Please find below a response to matters in respect of the proposed development plan for 99 Bena Road 19040 Revised Development Plan

99 Bena Road Korumburra 3950

PROPOSAL: DEVELOPMENT PLAN IN DPO6 AREA
APPLICANT: PLANNING CENTRAL
ADDRESS: 99 BENA ROAD, KORUMBURRA
DESCRIPTION: LOT 1 ON PLAN OF SUBDIVISION PS321371

VCAT REFERENCE	P709/2023
DEPARTMENT REFERENCE NO:	PROPOSED DEVELOPMENT PLAN – HILLVIEW RISE PTY LTD
PROPERTY ADDRESS:	99 BENA ROAD KORRUMBURRA VIC 3950

Figure 1 – Concept Plan

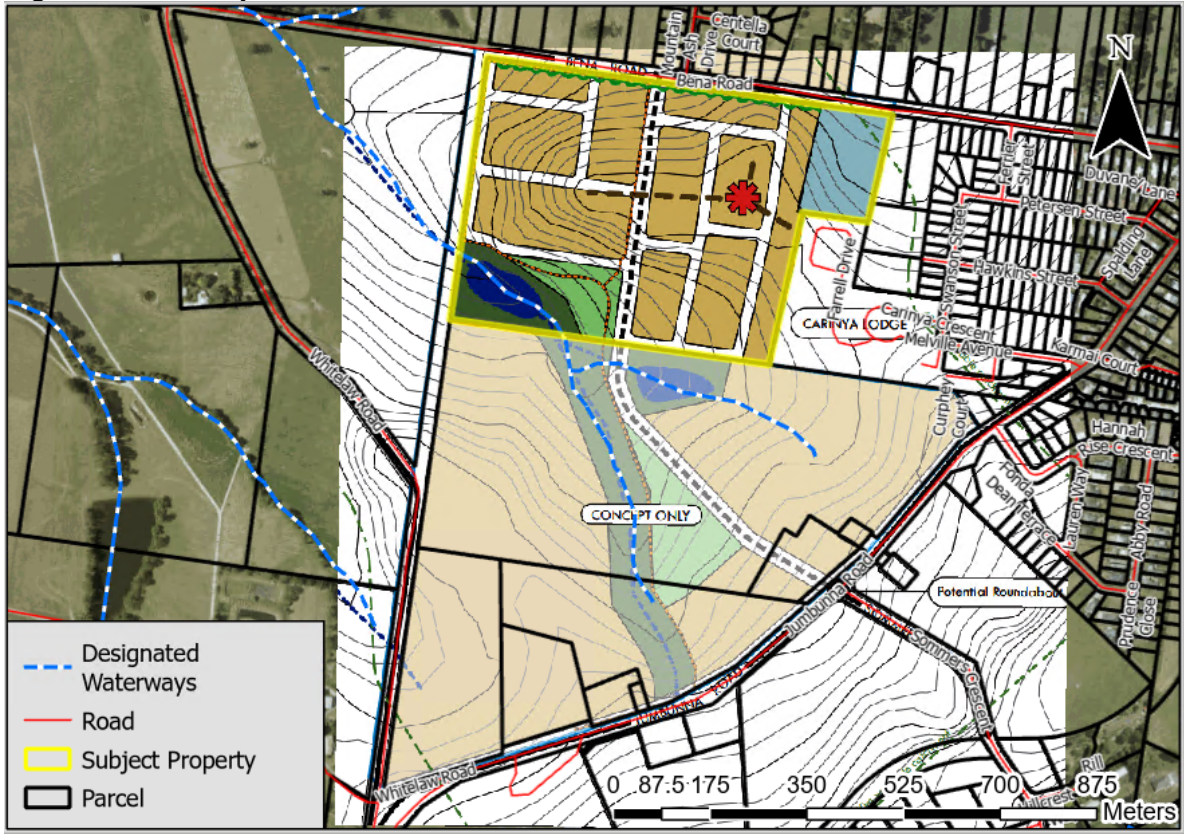
The Authority has reviewed the *Stormwater Management Plan – 99 Bena Road Korumburra* (Afflux Consulting, 14 February 2024) and is comfortable with the stormwater management concept that has been proposed. It is noted however, that it may be difficult to implement due to the steep terrain at the location where the wetland is proposed.

The Authority believes there may be benefit in locating the drainage reserve further to the south, across the property boundaries, and increasing its size so that the wetland can be located on marginally flatter land and to allow a larger single wetland to be constructed to treat stormwater from all properties rather than having two separate wetlands to treat stormwater from each area. The Authority is willing to consider conceding the requirement to protect the eastern most waterway should this approach be taken.

The Authority will require a detailed Stormwater Management Plan (SMP) prior to certification of Stage 1 of any subdivision proposal for the subject land that clearly identifies how stormwater runoff from the entire development will be managed and treated prior to discharge to the designated waterways including the proposed timing of works. It must also quantify the reduced loads of sediment, nutrient, and gross pollutants in kg/year.

Figure 1 – Proposed Development Plan

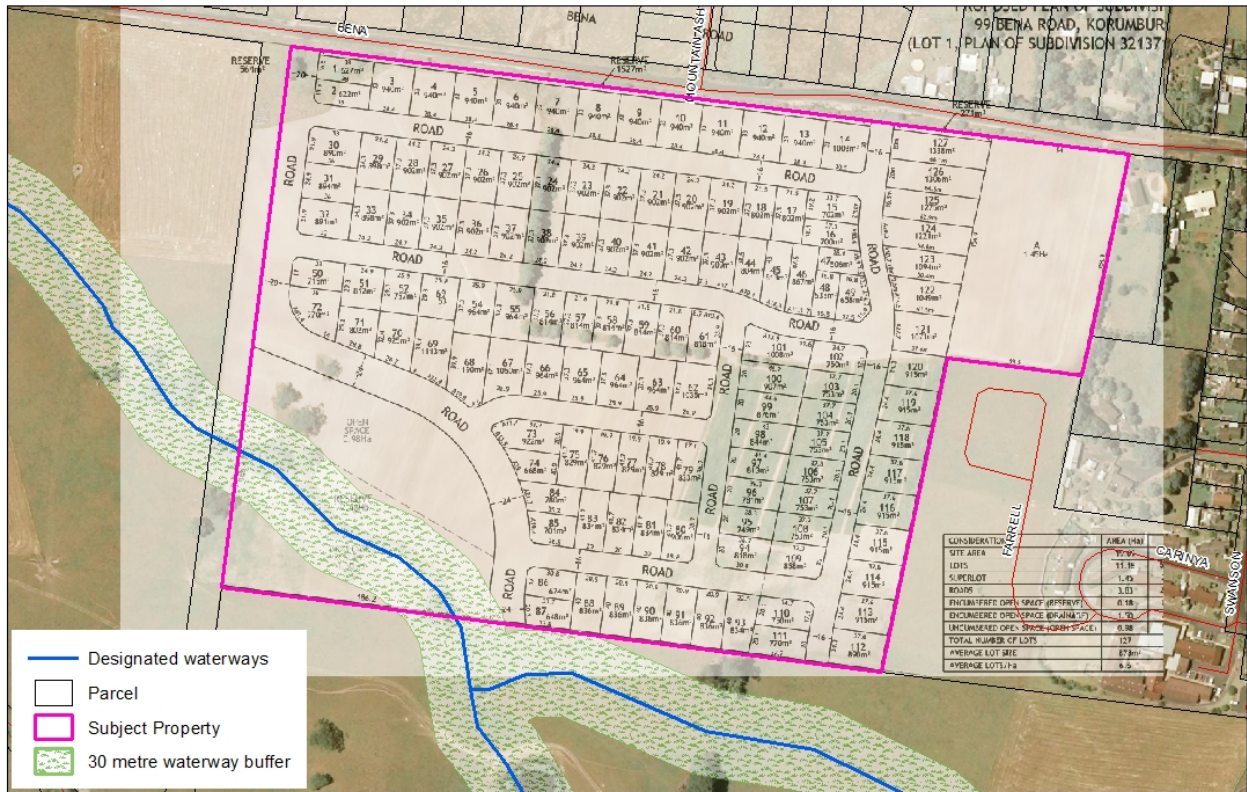
It is noted that on page 6 of the stormwater memo, a 40-metre riparian corridor is nominated for the designated waterway in the southwest of the subject property.

The Authority cannot support a reduced buffer of 40 metres. The development plan layout will need to ensure that the required 60 metre buffer has been incorporated and that the proposed road and lot configuration do not encroach on this buffer area.

To ensure the long-term protection of designated waterways and to minimise future maintenance requirements for any reserves created over the waterways, a Waterway Management Plan (WMP) will be required prior to certification of any stage of the subdivision containing the waterway.
